<b>Docket Number:</b>	15-MISC-05
<b>Project Title:</b>	2015 Bulk Storage Workshop
<b>TN #:</b>	207062
<b>Document Title:</b>	Steve Uhler Comments: Why is March referenced in the "Duck Chart"
<b>Description:</b>	N/A
<b>Filer:</b>	System
<b>Organization:</b>	Steve Uhler
<b>Submitter Role:</b>	Public
<b>Submission Date:</b>	12/17/2015 10:23:37 AM
<b>Docketed Date:</b>	12/16/2015

## **Why is March referenced in the "Duck Chart"**

## Growing Need for Flexibility

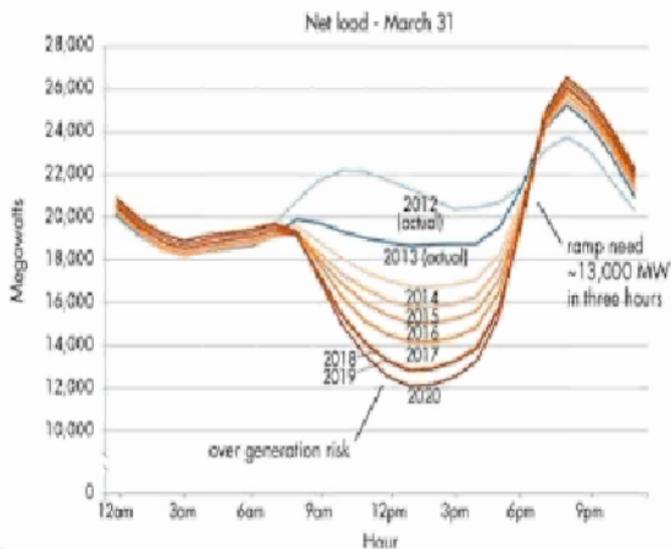
Why is March referenced in the "Duck Chart" when larger 3-hour ramps happen in November?

Please view video contained in the attached PDF.
